MONTGOMERY COUNTY HISTORIC PRESERVATION COMMISSION
STAFF REPORT

Address:	7315 Brookeville Rd., Chevy Chase	Meeting Date:	3/24/2021
Resource:	Individually Listed Master Plan Site Simpson Family House (35/72)	Report Date:	3/17/2021
Applicant:	Lacy Rice Matt McDonald, Architect	Public Notice:	3/10/2021
Review:	HAWP	Staff:	Dan Bruechert
Permit No.:	942304	Tax Credit:	n/a
Proposal:	Partial demolition, building addition, accessory structure construction, and subdivision

Figure 4: Proposed subdivision project, with the 19.3 feet proposed for transfer in red.

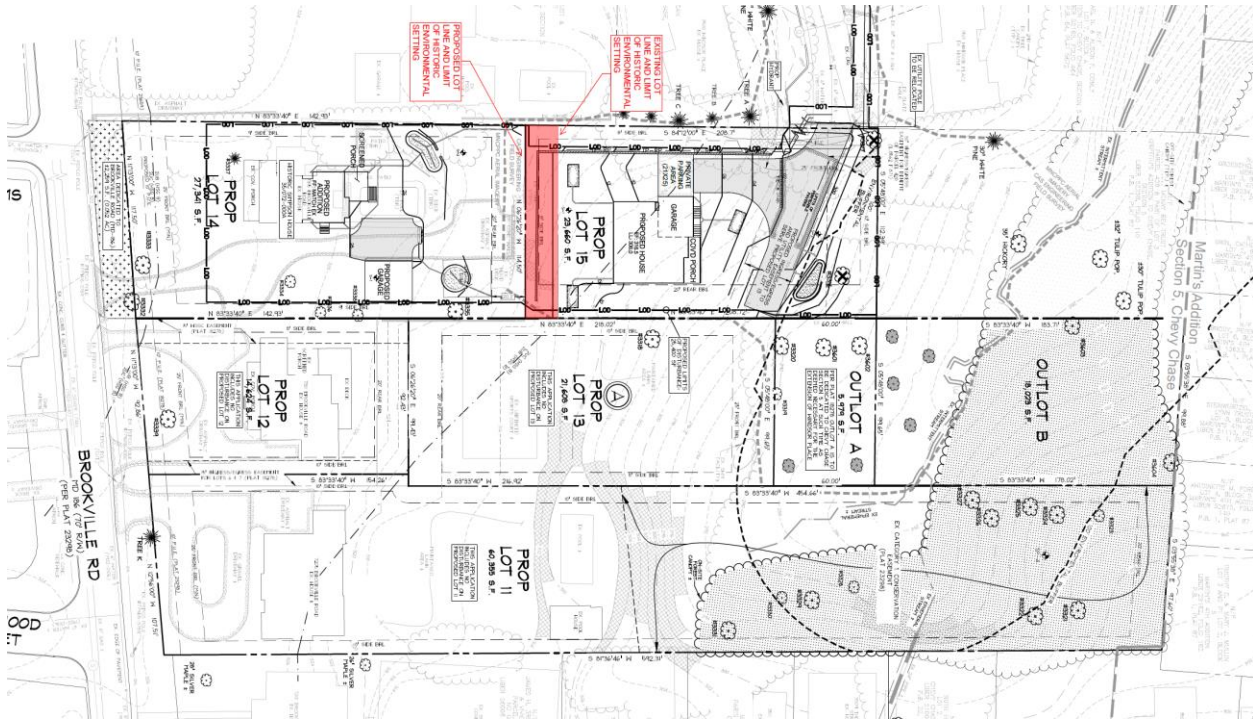
The applicant argues that the rear portion of the lot was included within the environmental setting because the entire parcel was designated on the Master Plan for Historic Preservation and that the boundary changes will have little to no impact on the historic character of the Master Plan Site. Staff finds this to be a rational argument and notes that when the Simpson House was constructed, the property was a 3.2 acre lot. A year after the house was constructed the property was reduced by slightly less than an acre. In subsequent years the lot was subdivided again and reduced the property's current .75 acre configuration.²

Staff notes that as long as this strip of land remains designated, a HAWP may be required for any changes to within this area on the Proposed Lot 15.

The house drawn on Lot 15 of the Preliminary Plan map is purely for illustrative purposes. Preliminary plans of subdivision set the lot boundaries, but do not dictate building location or form. That map also shows an 8' (eight-foot) side yard setback limit at the shared property line, which means that any new house constructed on the lot could conceivably be built up to that point.

Staff finds that the proposed lot reconfiguration will not have an adverse effect on the historic character or long-term preservation of the Simpson House.

- Does the HPC support the boundary adjustments proposed in the subdivision plan?
- If so, does the HPC support removing the proposed 19' 4" (nineteen feet, four inches) from the Simpson House Master Plan Site designation?

② Proposed Left Elevation
3/32" = 1'-0"

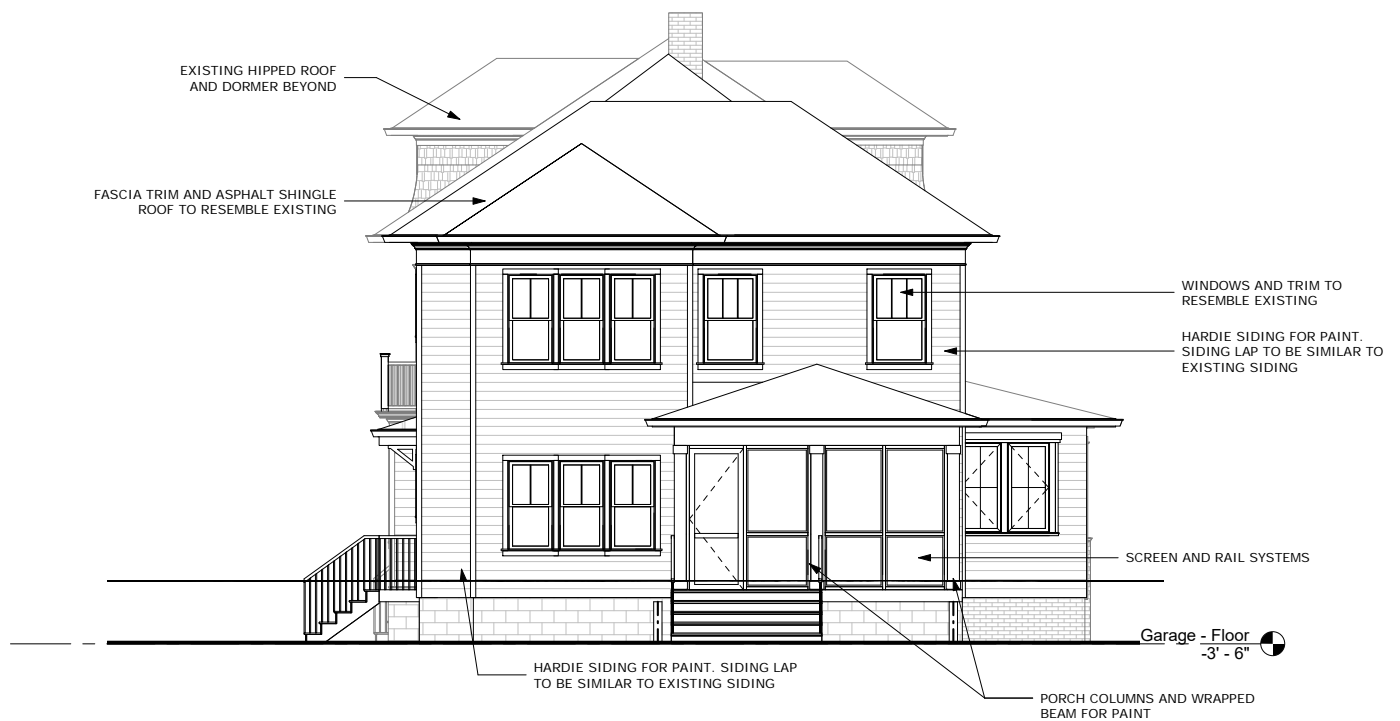
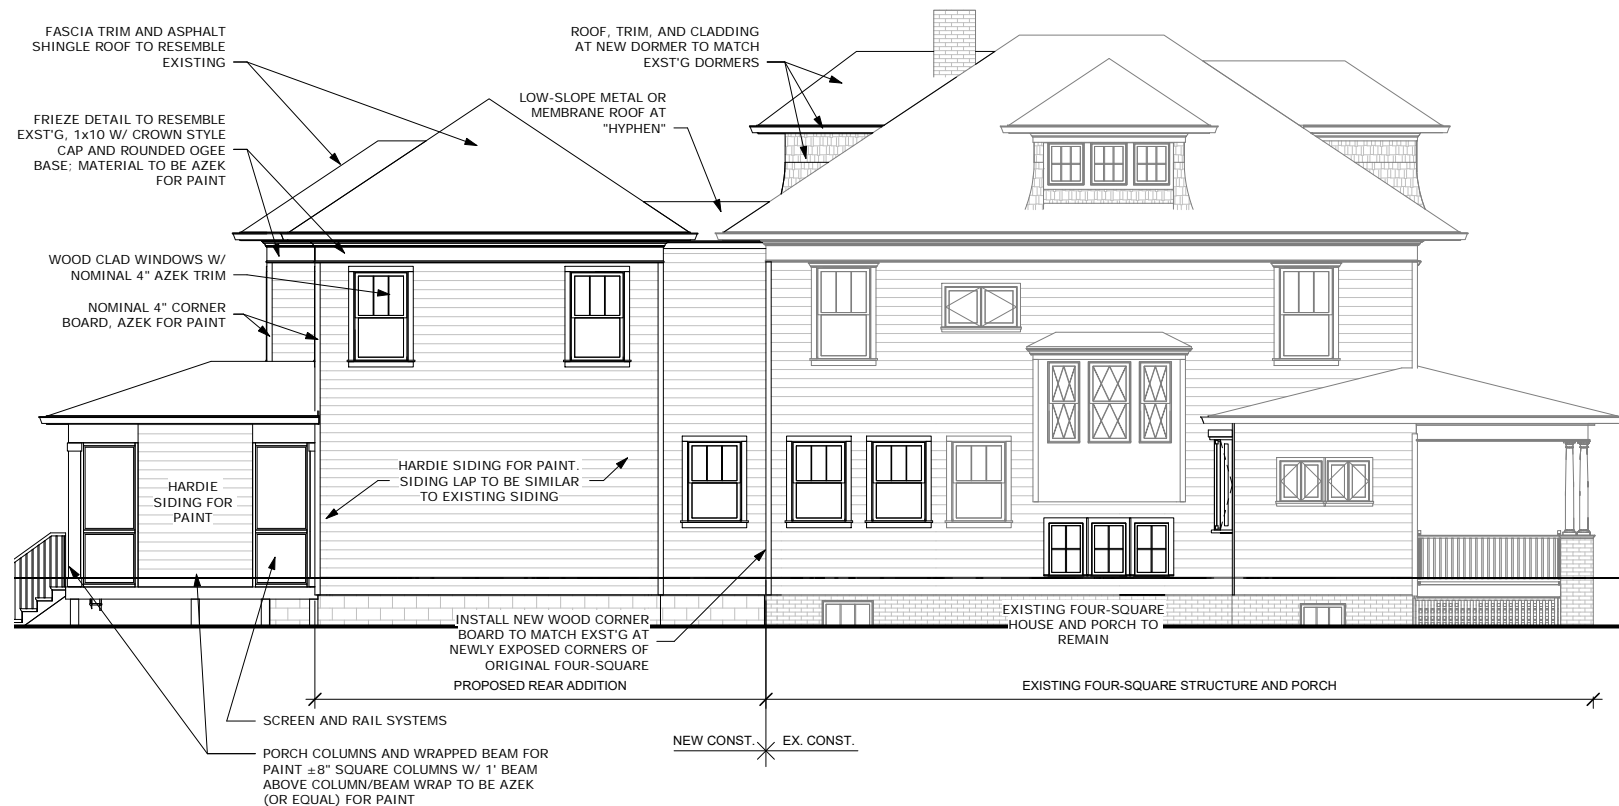
The one outstanding issue with the size and massing of the addition is the 2' 4" (two-foot, four-inch) addition projection on the left side of the house. Typically, additions need to be inset from the historic wall plane or at the very least even with the wall plane when a hyphen separates new from historic construction. This is an instance where Staff does not find an inset wall plane to be a necessity. First, the addition will be partially obscured by the office and hipped roof which project to the left of the historic foursquare form. Second, Staff finds the setback to be significant enough that the impact of the projection will be reduced. Third, Staff concurs with the Commissioners who voiced their support for a larger projection on the left side that it would not detract from the historic form.

Several other elements of the proposed addition warrant analysis. Staff notes that the window arrangement on the proposed addition does not appear to align in a rational pattern. The HPC typically requires windows on additions to historic buildings to be ordered and stacked. However, the historic windows are not ordered and stacked and seem to be installed wherever their installation made sense based on the interior plan. To require the windows on the addition to be stacked when they are not arranged in this manner on the historic house seems incongruent. Therefore, Staff finds the arraignment of windows on the proposed addition to be in keeping with the character of the house.

Proposed Elevations w/ Garage

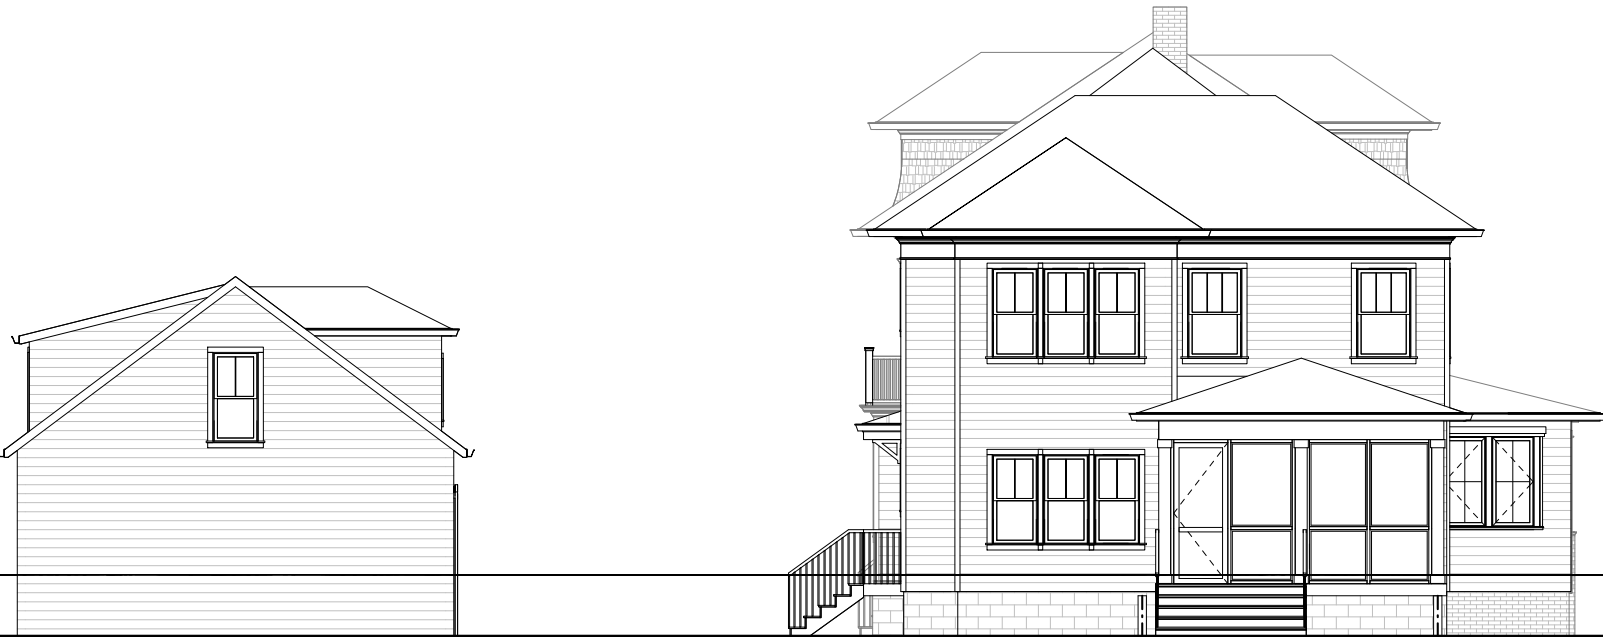
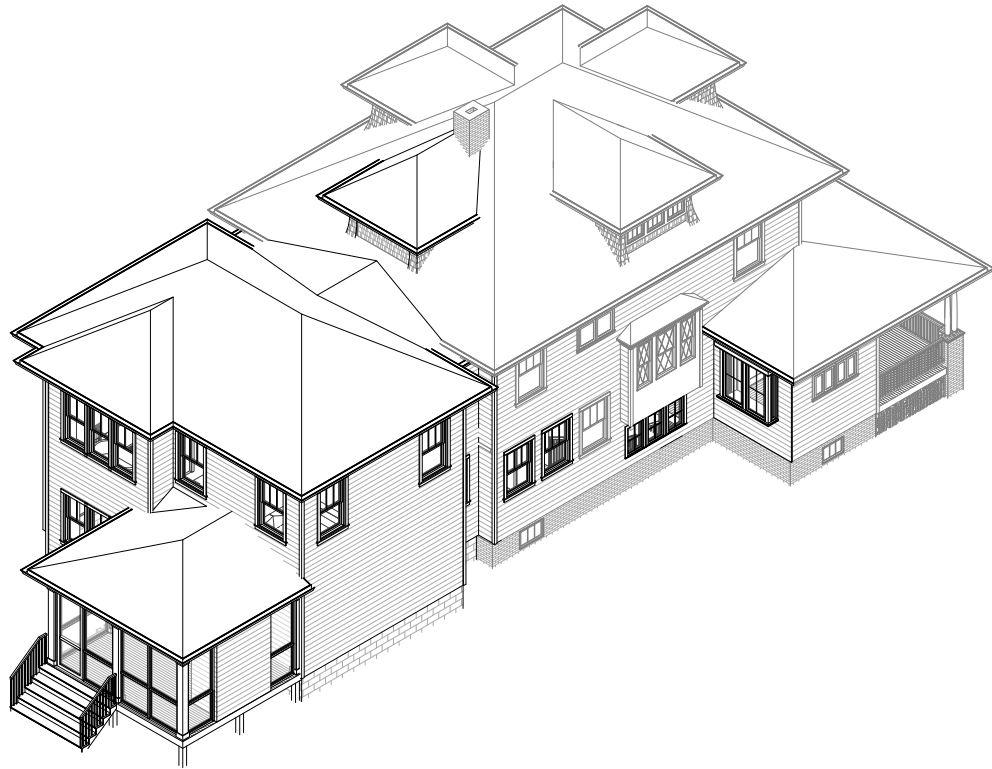
The proposed garage will be constructed much closer to Brookeville Rd. than the existing garage. This relocation is largely driven by the subdivision project (discussed below). The proposed garage is two-stories tall and has carriage-style doors. The second floor has a wall dormer to the rear (south) elevation and a pair of hipped dormers on the front (north) elevation. The hipped dormers have a pair of two-over-one sash windows and the wall dormer has three two-over-one sash windows. The exterior of the garage will be covered in fiber cement siding with architectural shingles, matching the details of the proposed addition.

Staff finds constructing a garage closer to the house will not have a significant impact on the historic house. The garage aligns with the rear plane of the proposed screened-in porch and is separated by the width of the driveway. Additionally, Staff finds that the proposed garage will be more than 150' (one hundred fifty feet) from the public right-of-way. Staff notes that while this is a Master Plan site, it is one of twenty that were nominated as a group as an alternative to expanding the Chevy Chase Historic District, and primary consideration should be given to how the property is viewed from the public right-of-way as opposed to how it is viewed in the round like most Master Plan Sites.

Staff finds that while the garage is large it will not detract from the character of the house and recommends the HPC approve the application.
